Design Review Commission Report

Meeting Date: Thursday, November 6, 2014

Subject: **309 North Rexford Drive (PL1429383)**

A request for an R-1 Design Review Permit to allow for construction of a new two-story single-family residence located in the Central Area of the City south of Santa Monica Boulevard. The Commission will also consider adoption of a Categorical Exemption, pursuant to the California Environmental Quality Act.

PROPOSED
SITE PLAN

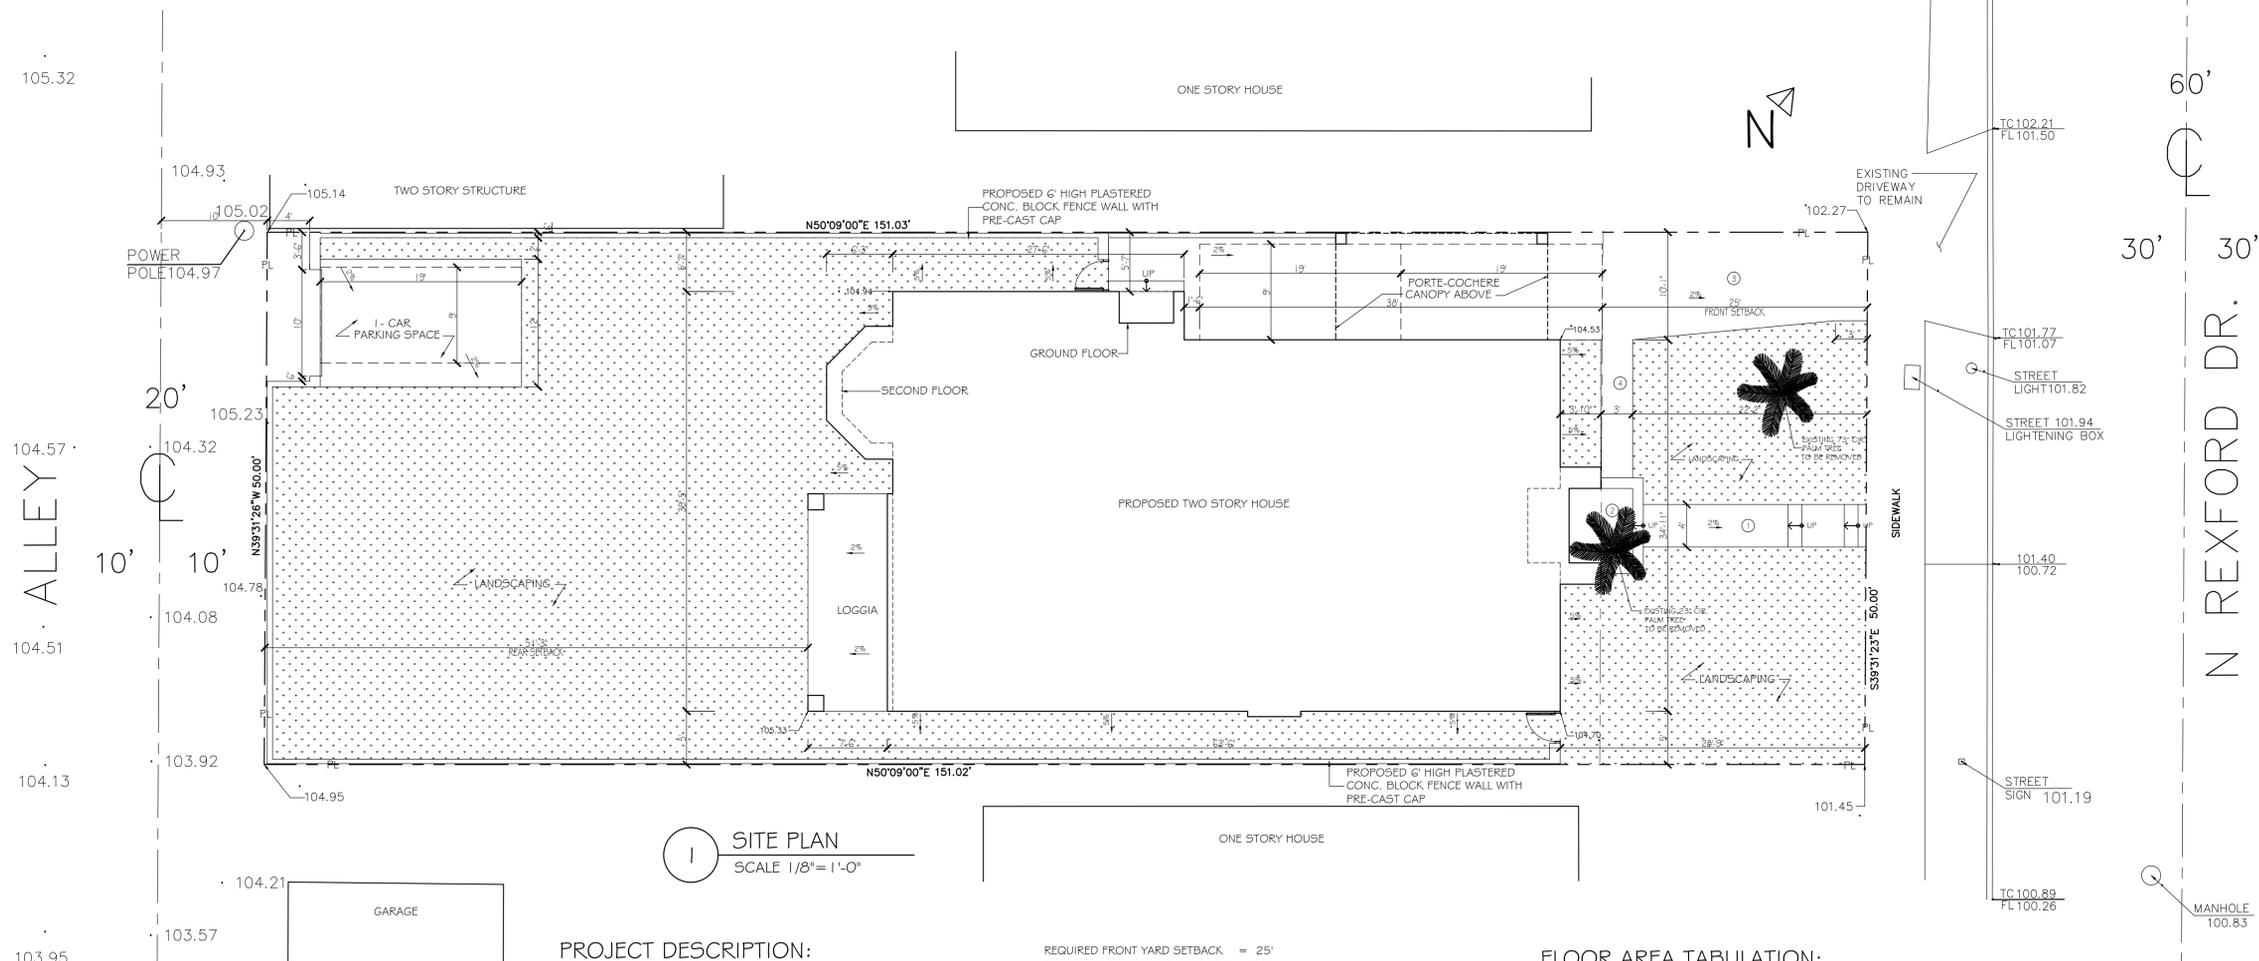
Based on a review conducted by the Urban Design Team, the façade design appears to be well proportioned, exhibits a pleasing scale and massing, and fits in well with the streetscape. The Applicants may consider using a more traditional front entry door design. The plans do need to be revised during the plan check process to decrease the length of the porte cochere in order to provide a full 9'x19' parking space beyond the porte cochere to comply with code.

The landscape plan proposed for the project seems a bit heavy and lacks the symmetry of the house. In addition, a planting separation strip will be required between the subject driveway and the adjacent neighbor's driveway.

1. A planting separation strip shall be provided between the driveway of the subject property and the driveway of the adjacent neighbor to the north.
